Subject: Bowman Dam Hydroelectric Project  
Docket P - 14791; Oregon Department of Fish and Wildlife Comments on the  
Pre-Application Document

### Oregon Department of Fish and Wildlife Comments on Bowman Dam Hydroelectric Project Pre-Application Document FERC P - 14791

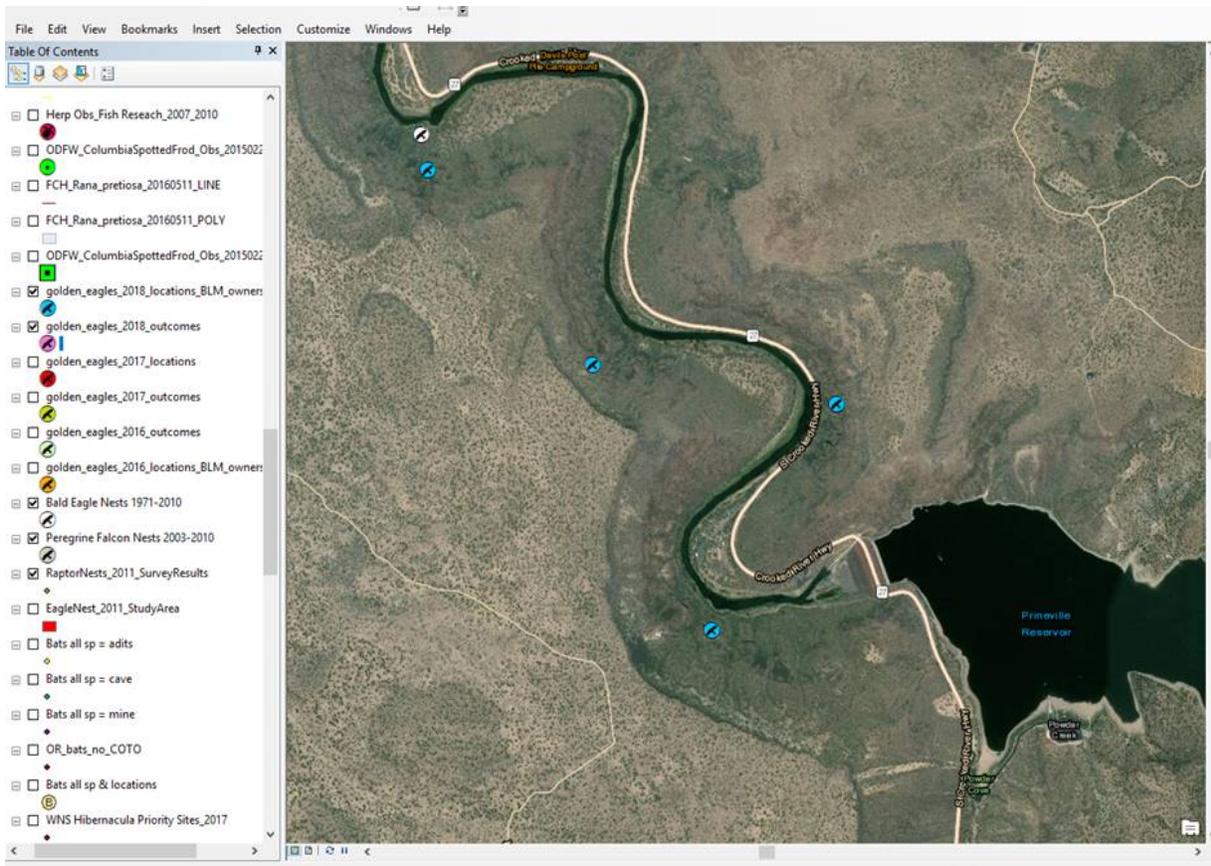
ODFW is providing the following information on raptor nest in the vicinity of the Project as a means of helping bolster section 3.2.6.1 and inform new studies and the preparation of the draft license application.

OID should consult with biologists from ODFW, BOR and the USFWS to determine the location of bald and golden eagle nest and roost sites in the project vicinity. Specific protective guidelines should be put in place that direct proposed Project activity near these sites.
